STAFF RECOMMENDATION

NCPC File No. 6418

U.S. NATIONAL ARBORETUM
INSTALLATION OF SECURITY FENCE
3501 New York Avenue, NE

July 1, 2004

CHAIN LINK PERIMETER FENCE ELEVATION

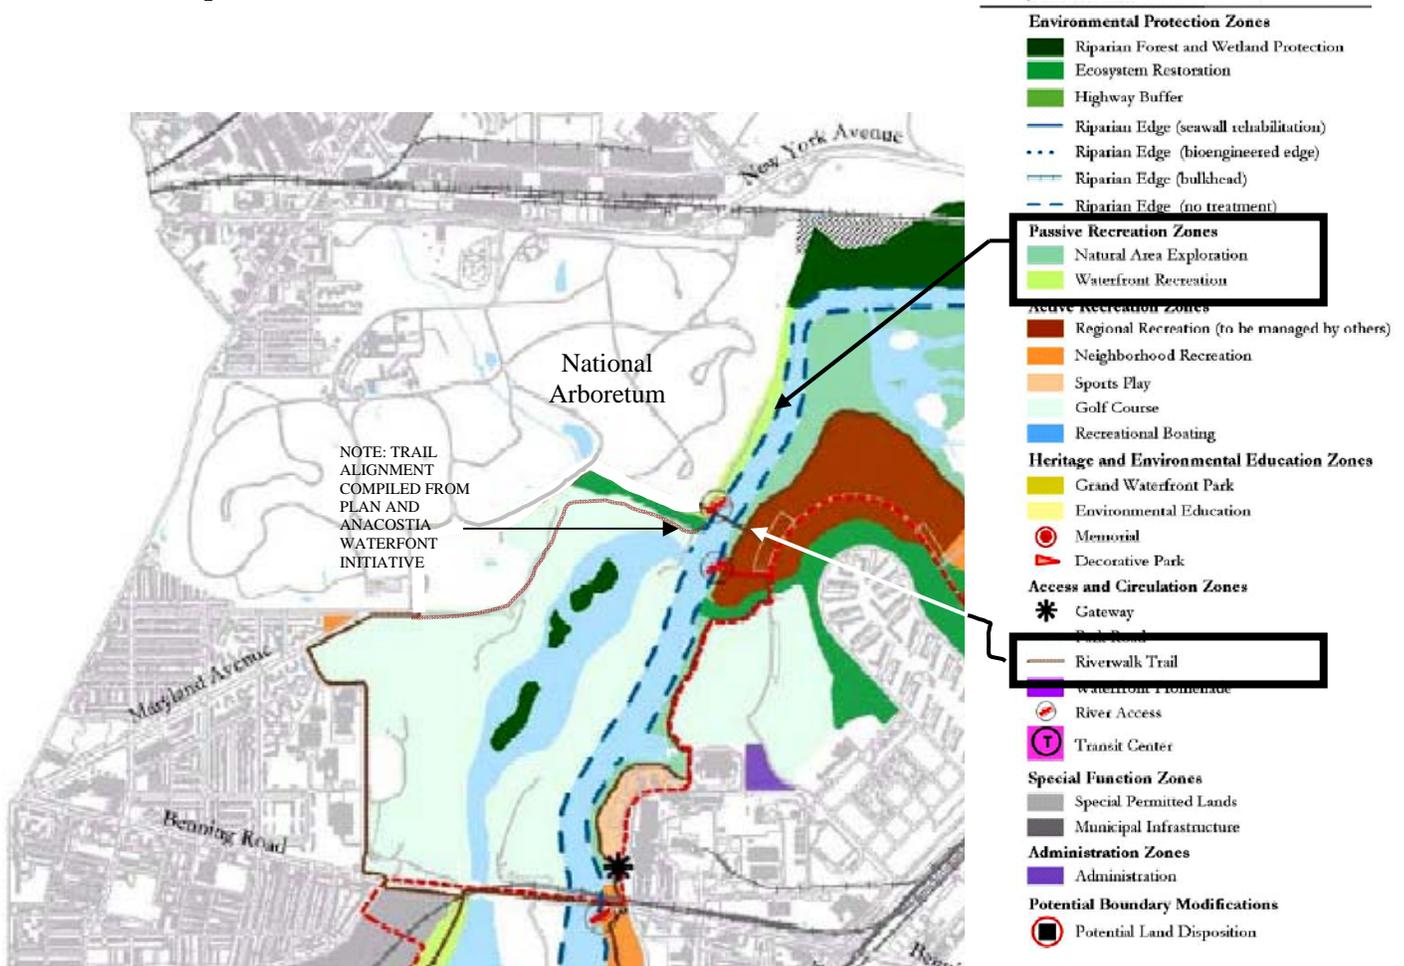
Requires that the currently installed barbed-wire fence extension be removed and that all current posts and fence fabric be painted black.

Nevertheless, staff finds the Arboretum decision to complete the design, its natural metal galvanized appearance, and installation of the fence prior to Commission review extremely regrettable and in violation of federal requirements for Department projects in the District of Columbia. Also, the presence of the barbed-wire extension at the top of the fence adds little in actual deterrence effect but appears very incongruous with the river shore environment, as perceived by the public, due to its proximity to the river and the natural environment and public views enjoyed at that park location. Moreover, because the Director of the Arboretum has acknowledged the intent for revising the perimeter fence design when the Anacostia Riverwalk trail is implemented, staff concludes the barbed wire should be removed from the fence design. If the barbed section removal is problematic to the Department, staff recommends the fence height be extended two feet; similar to fence extensions that have occurred at Metrorail right-of-way locations. The applicants offer to change the color of the fence posts and chain link to reduce its visibility is also fully endorsed by staff. As a further note to the endeavor, staff also recommends that the Director of the Arboretum coordinate the operation of the service vehicle
